Access Compliance Report

Public Rights-of-Way

(Curb Ramps)

Intersection ID: 32296	Main Street: BAILEYWICK_RD	Cross Street: LISHA_LN	Location: SW
ADA ID: 41659E0B58C5	Ramp Type: PerpDiag	Initial Pass/Fail: Pass	Overall Compliance: No
			Severity Score: 10.25

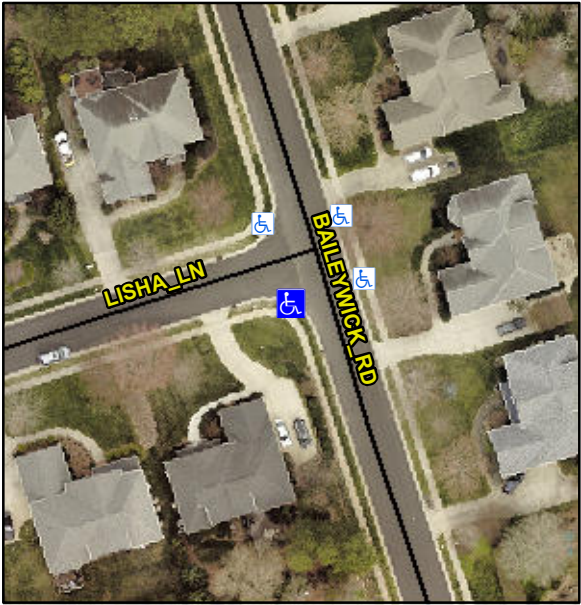
Codes/Mitigation Info/Possible Solution		Field Measurements/Component Compliance			
	Possible Solutions:				
	Remove & Replace Curb Ramp With Two New Directional Ramps or Equivalent.				
	Surveyor Notes:				
	N/A				
	PROW/ADA:				
	Not Found, R304.5.3, R304.2.1, R305				
	Street 1 Name	BAILEYWICK RD			
	Stop Condition-Street 2	None			
	Street 2 Name	LISHA LN			
	Stop Condition-Street 1	StopSign			
	Total Cost:	\$ 3200.00			
Compliance	Description	Data	Compliance	Description	Data
N/A	Ramp Length (in)	62.0	Yes	Ramp Slope (%)	7.8
Yes	Ramp Width (in)	48.0	No	Ramp XSlope (%)	2.4
N/A	Flare Type LT	Sloped	N/A	Flare Type RT	N/A
N/A	Flare Slope LT (%)	7.7	Yes	Flare Slope RT (%)	4.2
N/A	Flare Traversable LT?	Yes	N/A	Flare Traversable RT?	Yes
No	Landing Length (in)	30.0	No	DWS Provided?	No
Yes	Landing Width (in)	48.0	N/A	DWS Contrast?	No
Yes	Landing Slope (%)	1.2	N/A	DWS Length (in)	N/A
No	Landing X Slope (%)	3.0	N/A	DWS Full Width?	No
